Application for Licence Amendment

Licence Number	L8644/2012/1
Licence Holder	Big Bell Gold Operations Pty Ltd
ACN	090 642 809
File Number	2012/002162-1
Premises	Cue Gold Operations – Tuckabianna Project Mining Tenements: M20/55, M20/108, M20/111, M20/176, M20/183, M20/195, M20/208 and M20/247 CUE WA 6640 As defined by the Premises map attached to the Revised Licence
Date of Report	21 October 2022
Decision	Revised licence granted

Figure 2: Standing water levels at the TSF2

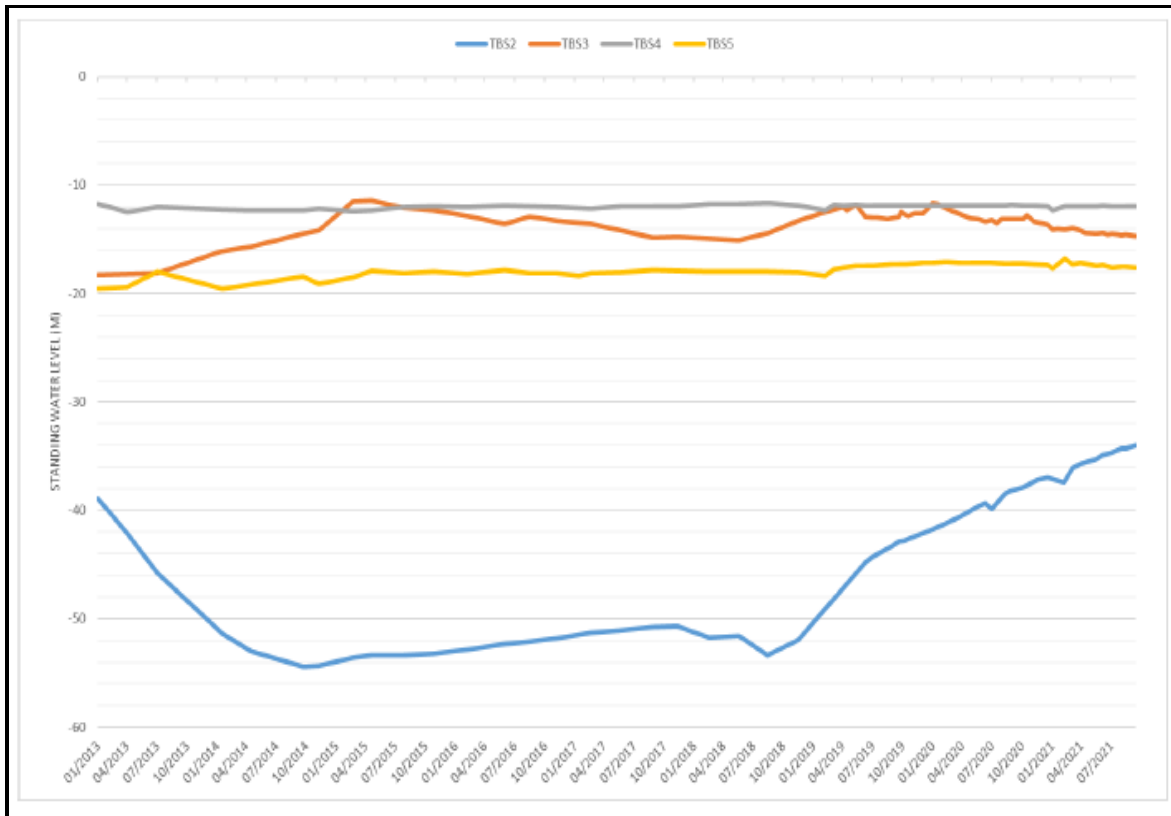
- Given the plan to raise the TSF, has any further investigation been undertaken, or progress made in repairing the lower embankments to ensure the embankments are not impacted as the facility moves into an operational phase?*

- Provide the details to address risk of PMP flood events of the TSF2 embankments as per consultant recommendations.*
- Describe the process Westgold will follow to ensure that the rate of rise for TSF2 will be managed as it currently appears it would be based on some form of administration control*

- DWER has included conditions in the licence requiring alterations are made to the perimeter toe drain to protect the TSF2 against a Probable Maximum Flood (PMF) event.
